**ADDENDUM NO. 2**

**PALOLO VALLEY HOMES MODERNIZATION, PHASE 3**  
HONOLULU, OAHU, HAWAII  
Tax Map Key No.: (1) 3-004-015

HPHA Job No. 15-016-108-Z  
IFB-CMB-2016-17

May 27, 2016

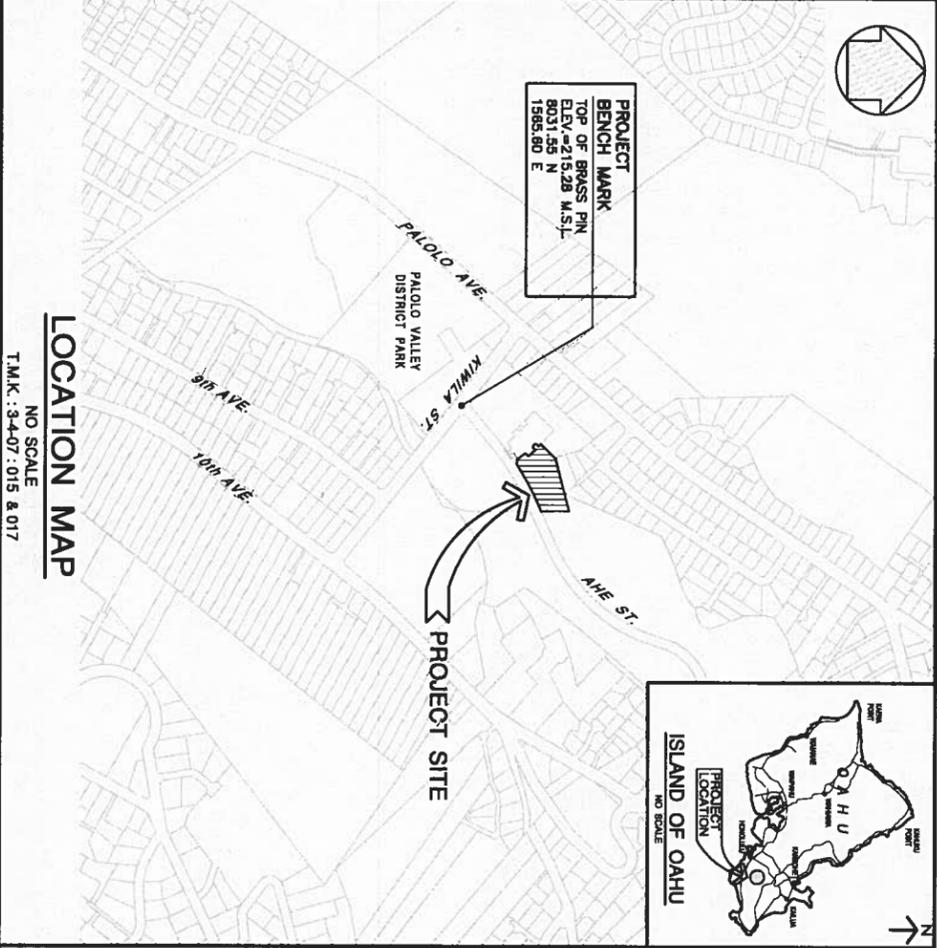
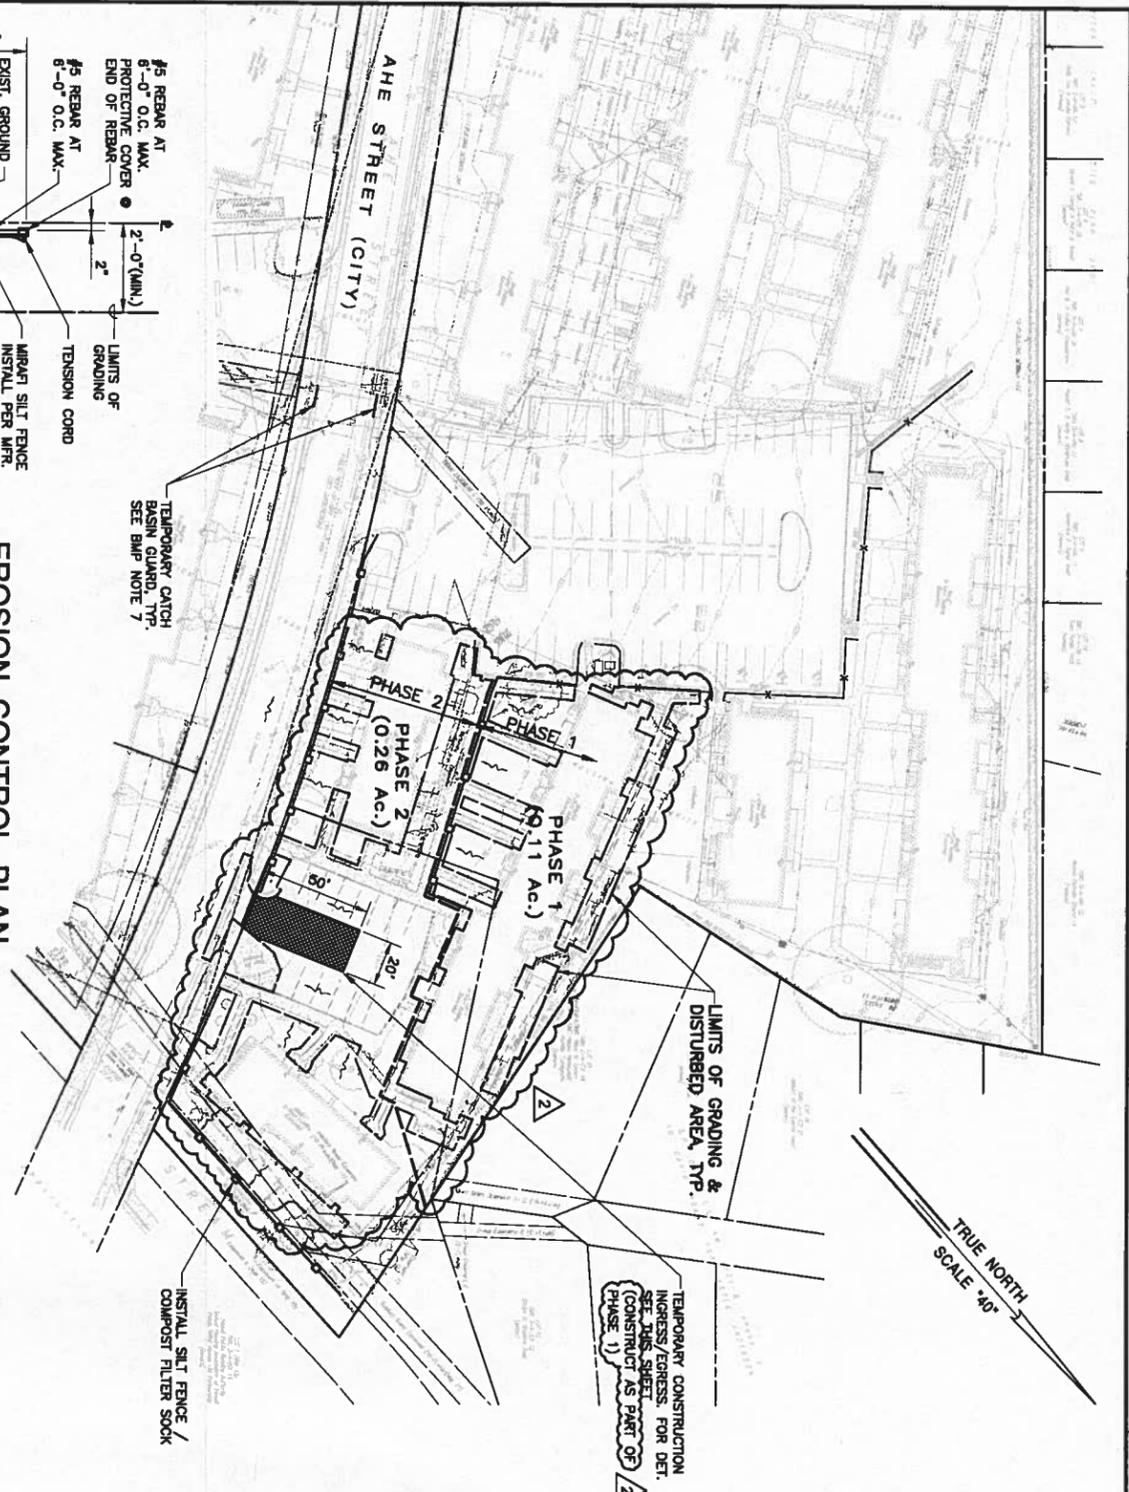
1. Drawing No. C-001
  - a. Revised Index of Drawings to include Drawings E1.1 and E5.1
  - b. Added TMK lot for Building 20.
  - c. Added CP No.
2. Drawing No. C-104
  - a. Added callout that the Temporary Construction Ingress/Egress is to be in the first phase.
  - b. Revised BMP notes.
  - c. Added phasing line to legend.
  - d. Revised Limits of Grading & Disturbed Area.
3. Drawing No. C-301
  - a. Revised limits of grading & disturbed areas to include walkways.
  - b. Revised graded and disturbed area in estimated earthwork quantities table.
  - c. Revised legend.
  - d. Revised Note 12.
4. Drawing No. C-302

**C-302**  
 SHEET 10

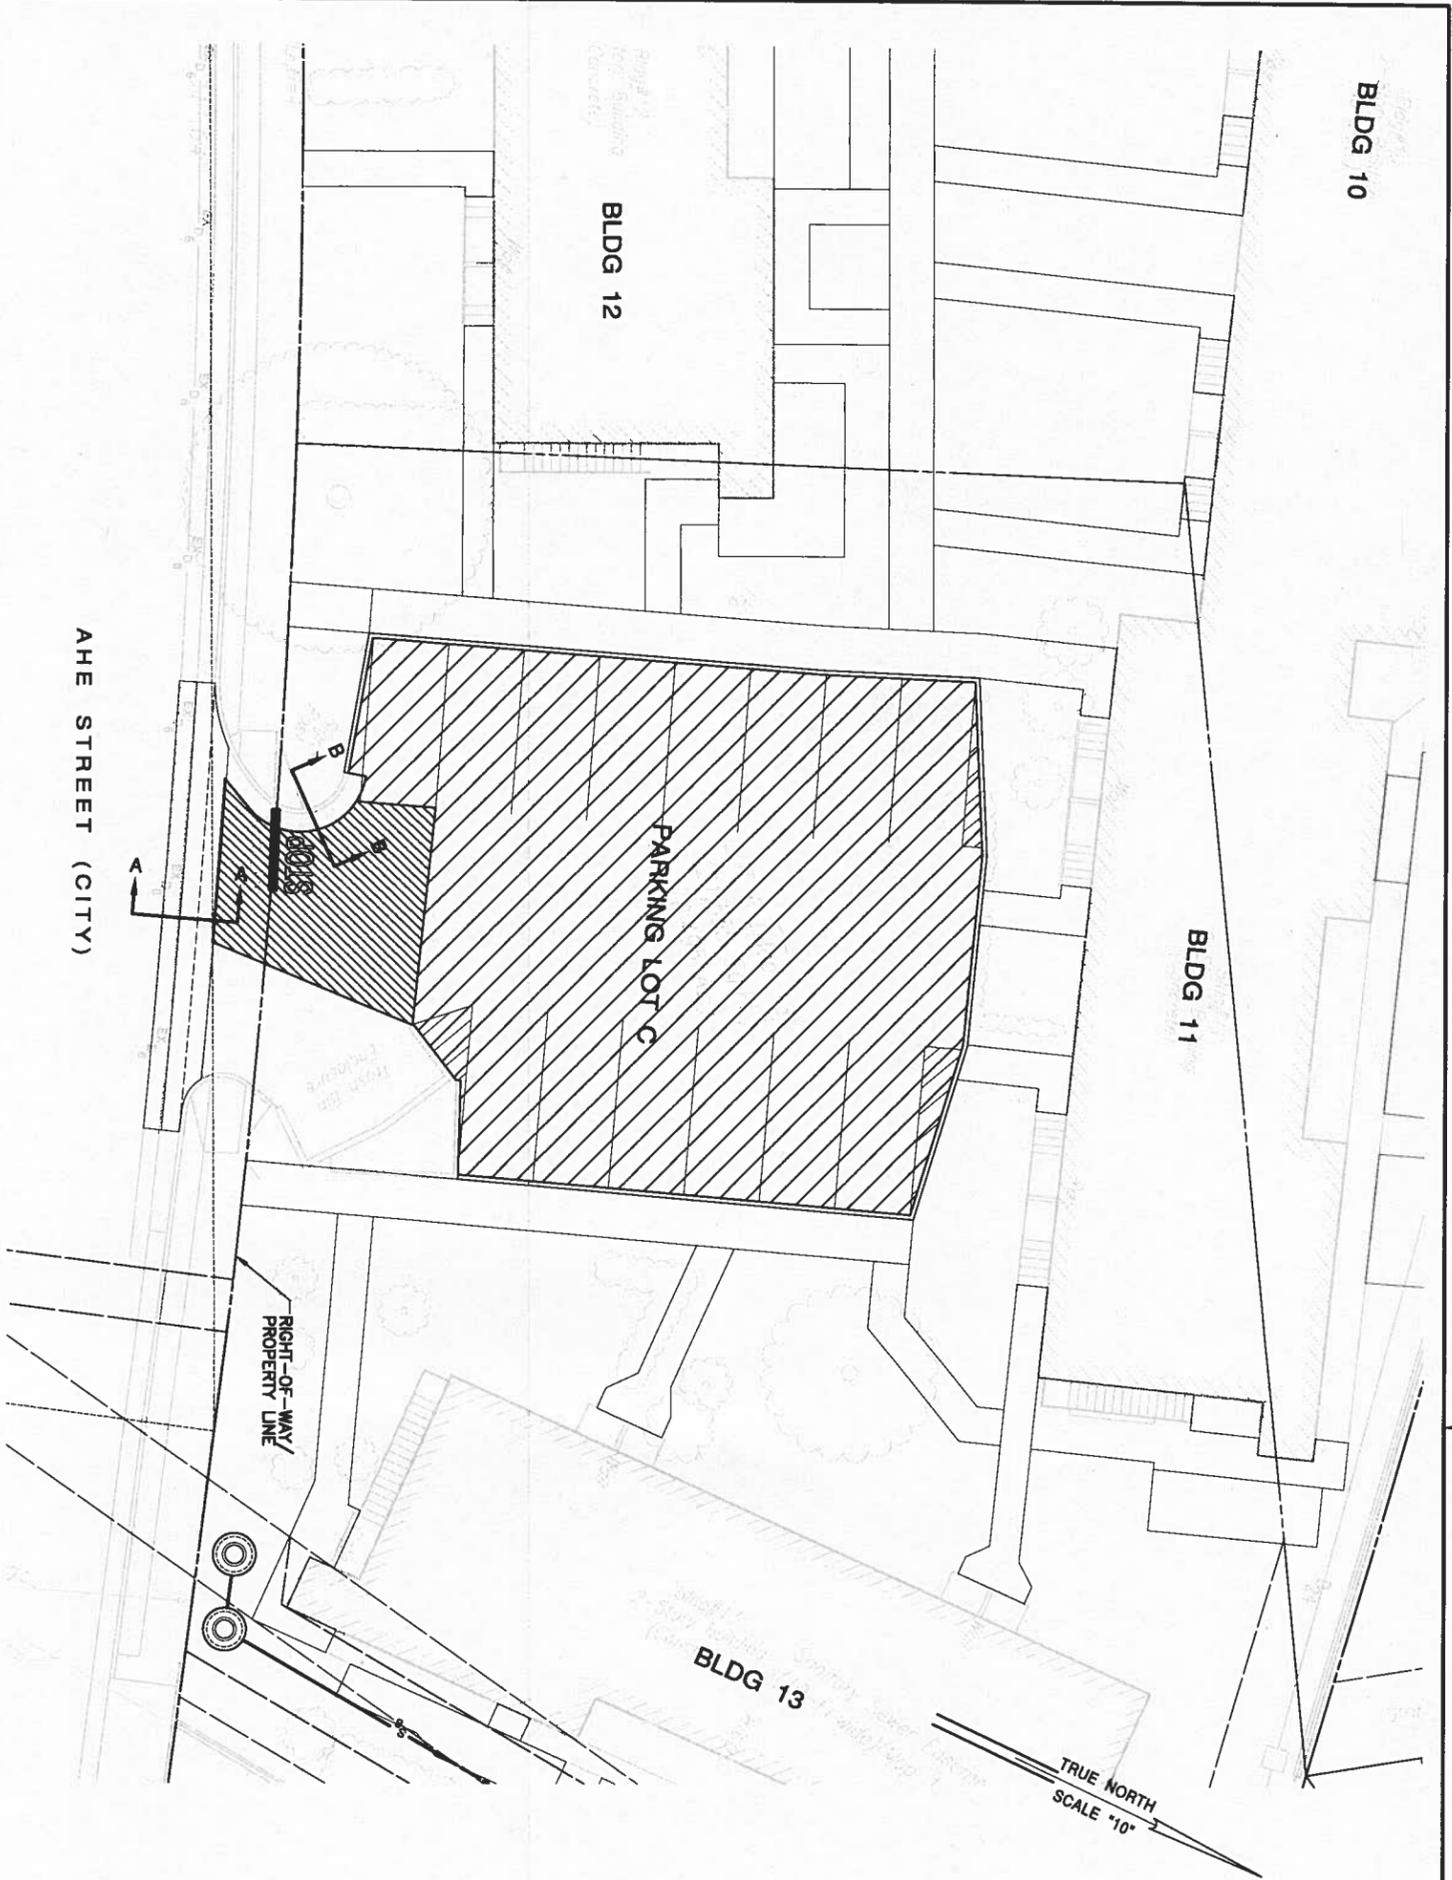
- a. Revised limits of grading and disturbed area to include walkways.
  - b. Revised Note 14.
  - c. Revised legend.
5. Drawing No. C-303
- a. Revised limits of grading and disturbed area to include walkways and Parking Lot C.

ENGINEERING CONCEPTS, INC.	HAWAII JOB NO.	DRAWING NO.
15-016-108-Z		C-401
PAOLO VALLEY HOMES MODERNIZATION PHASE 3	DEPARTMENT OF HUMAN SERVICES HAWAII PUBLIC HOUSING AUTHORITY

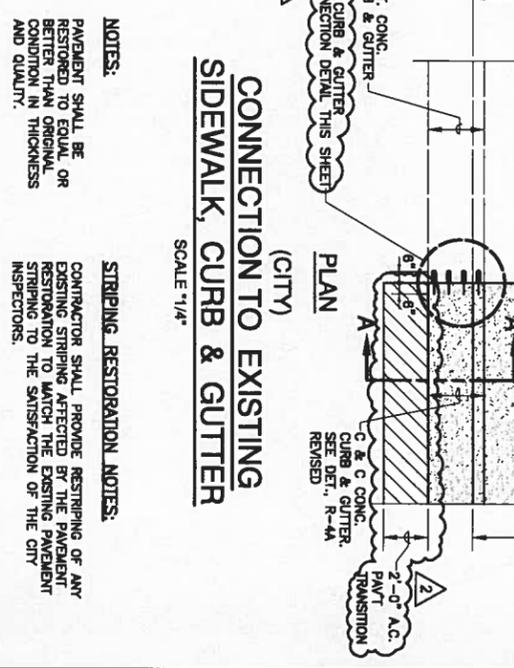
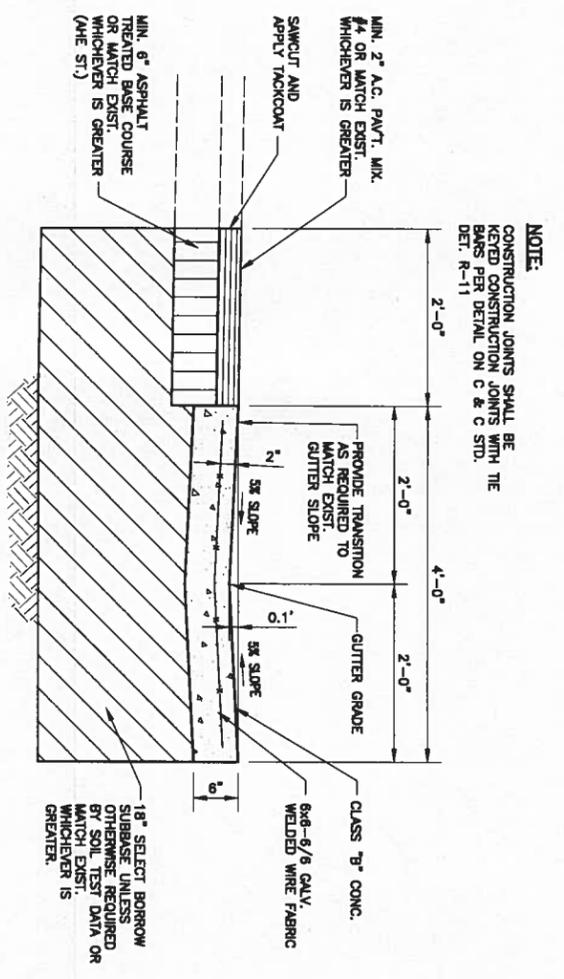
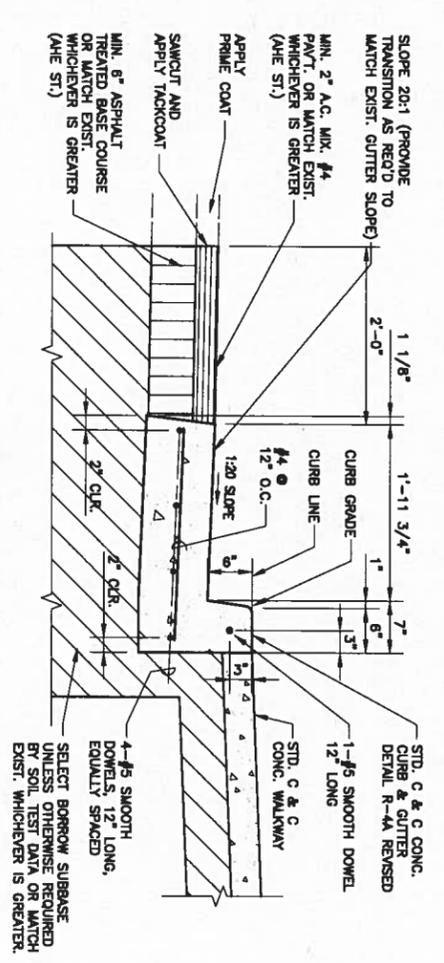
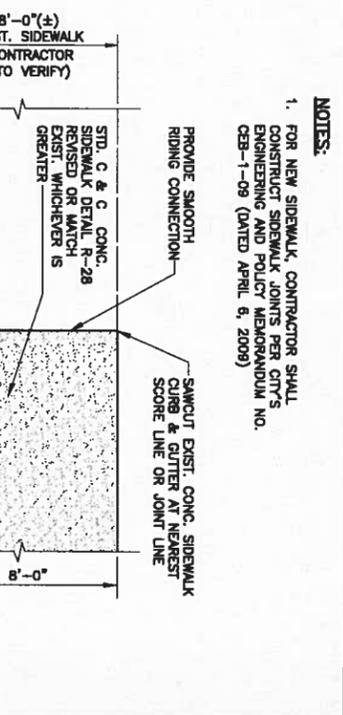
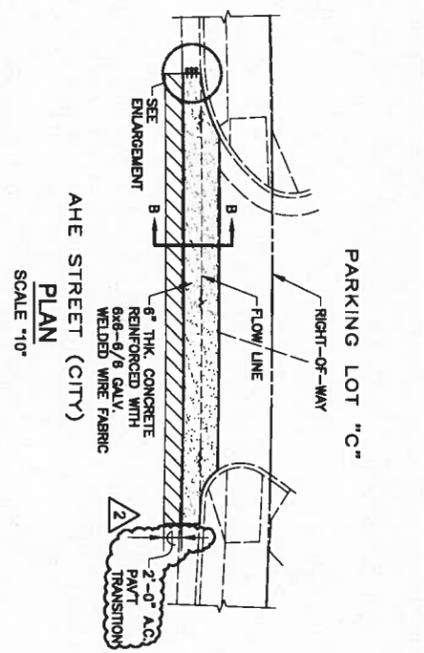
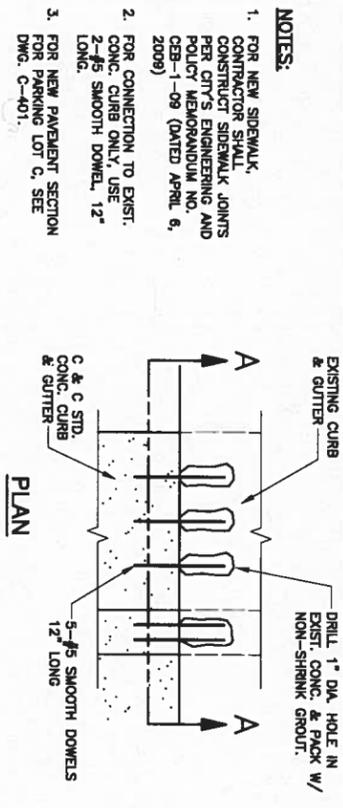
6. Drawing No. C-401
- a. Added callout for accessible path to thru gutter detail.
  - b. Revised Notes.
7. Drawing No. C-501
- a. Added callout for 2' A.C. transition.

DRAWING NO. **C-501**  
 SHEET **14** OF **88** SHEETS

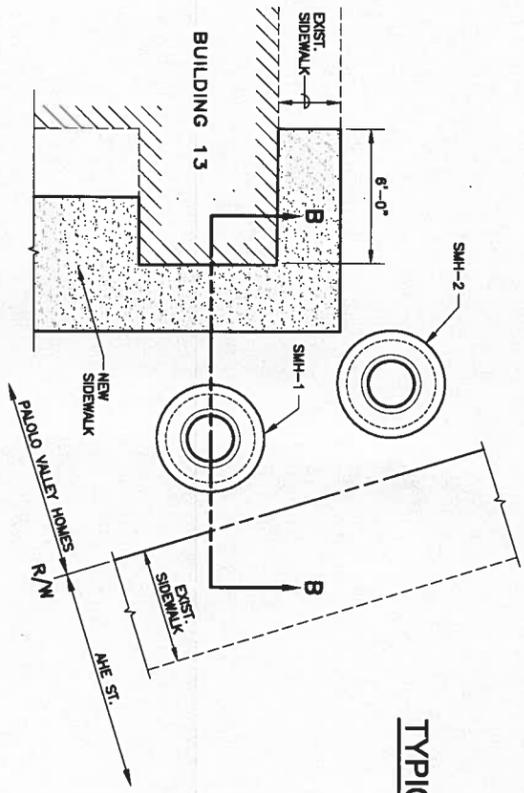
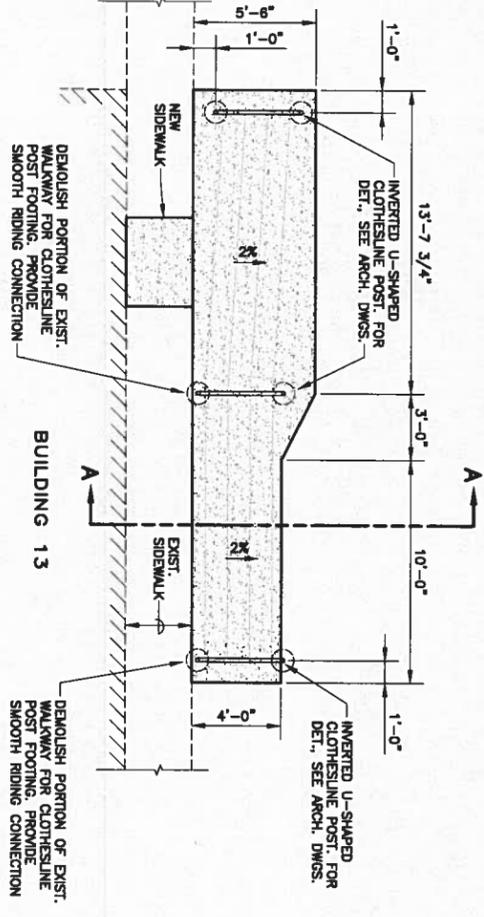
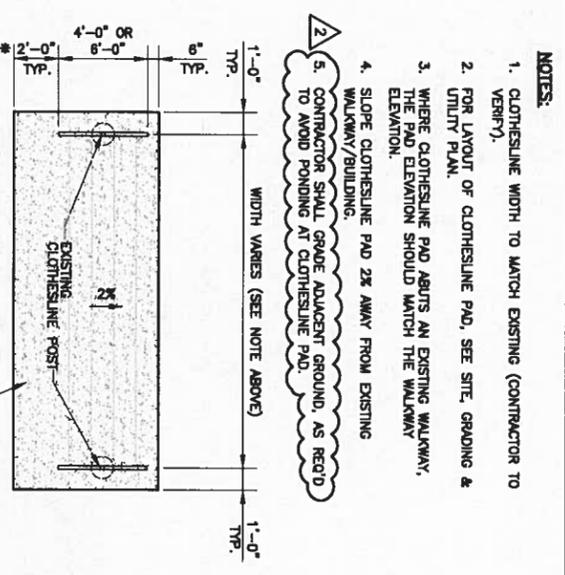
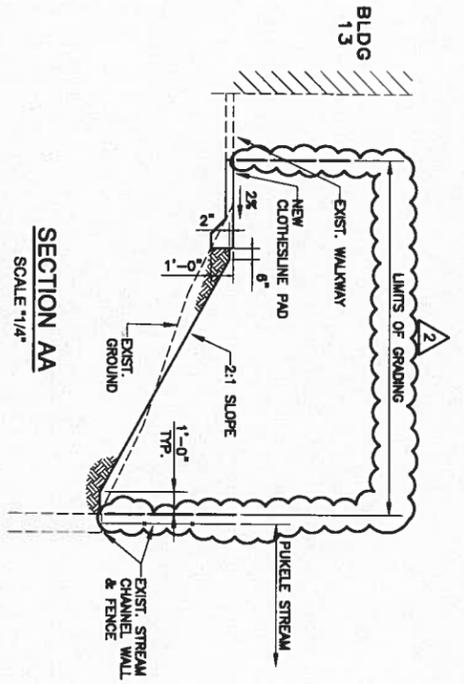
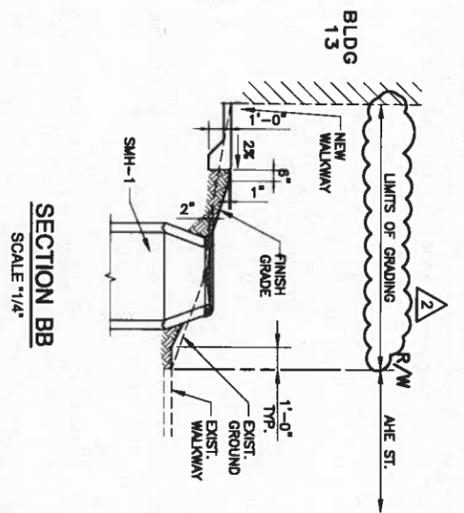
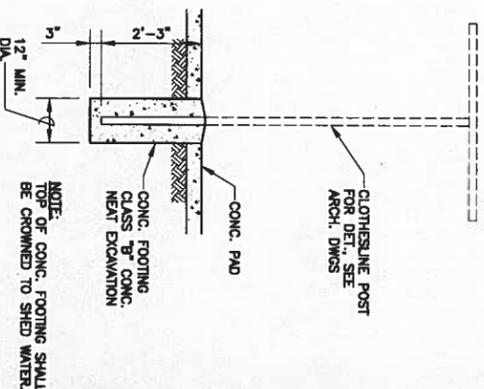
- b. Revised details.
8. Drawing No. C-503
- a. Added Note 5 to typical clothesline pad detail.
  - b. Added Limits of Grading to grading sections.
9. Drawing No. A-101
